AMENDMENTS TO THE DRAWINGS:

REMARKS

FIG. 2

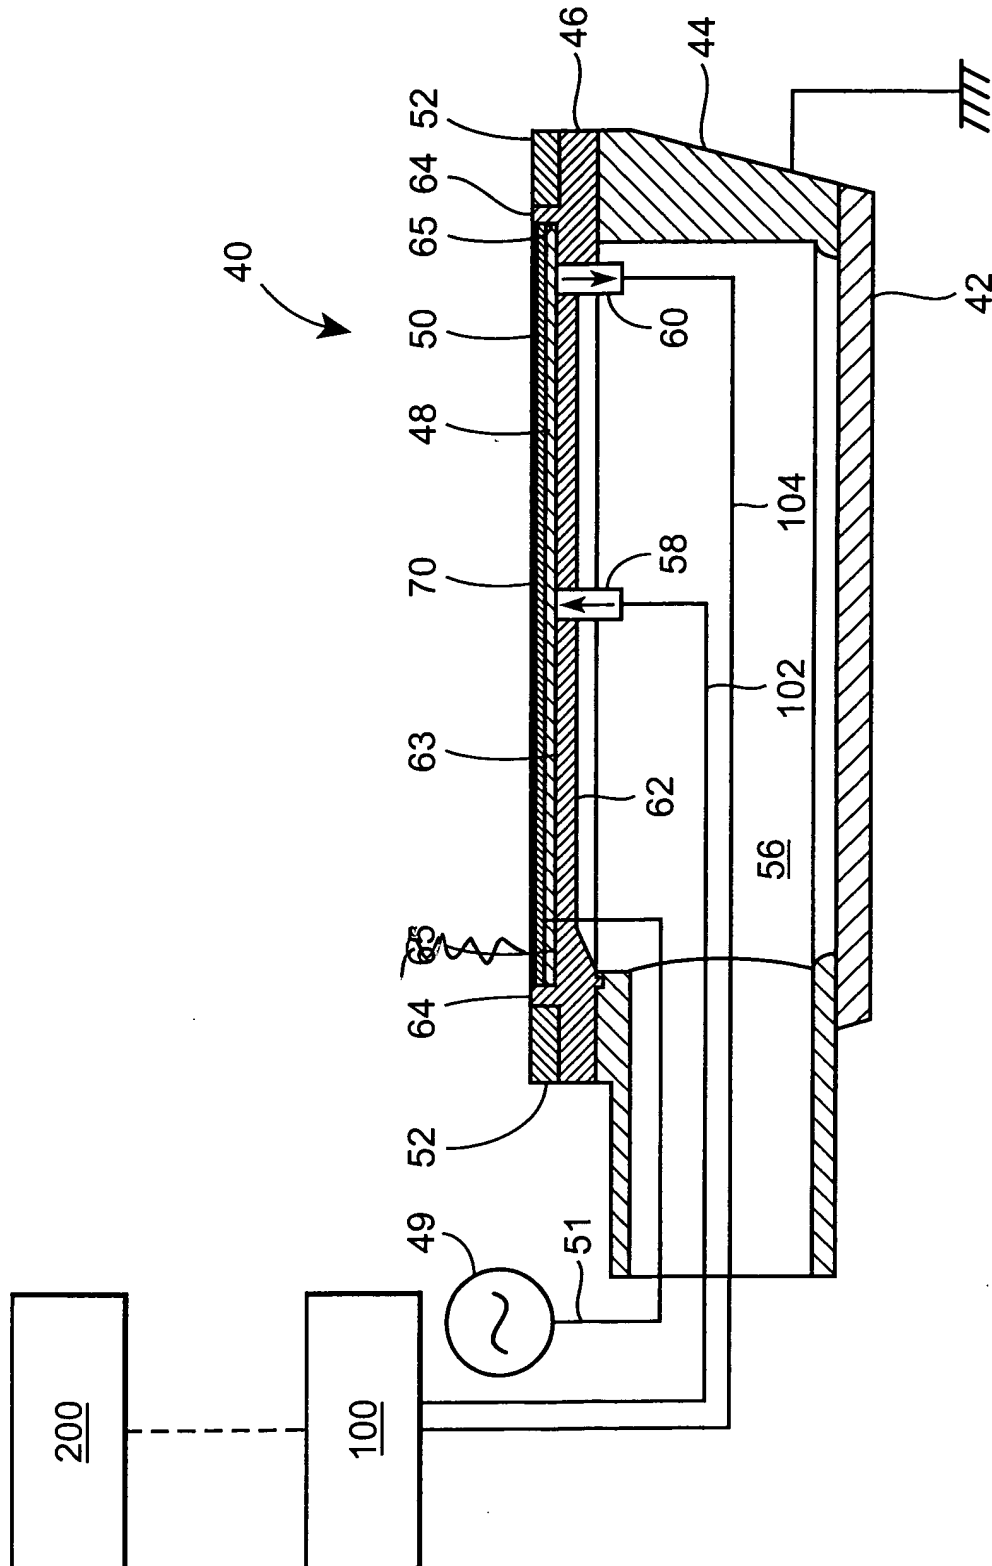
The attached sheet of drawings includes changes to FIG. 2. This sheet, which includes FIG. 2, replaces the original sheet including this same figure. In FIG. 2, reference number "65" and an associated lead line are deleted.

The Official Action objects to the drawings under 37 C.F.R. § 1.84(p)(5). In the Replacement Sheet for FIG. 2, submitted herewith, the reference number "65" and an associated lead line have been deleted. As such, Applicant respectfully requests the withdrawal of the objection.
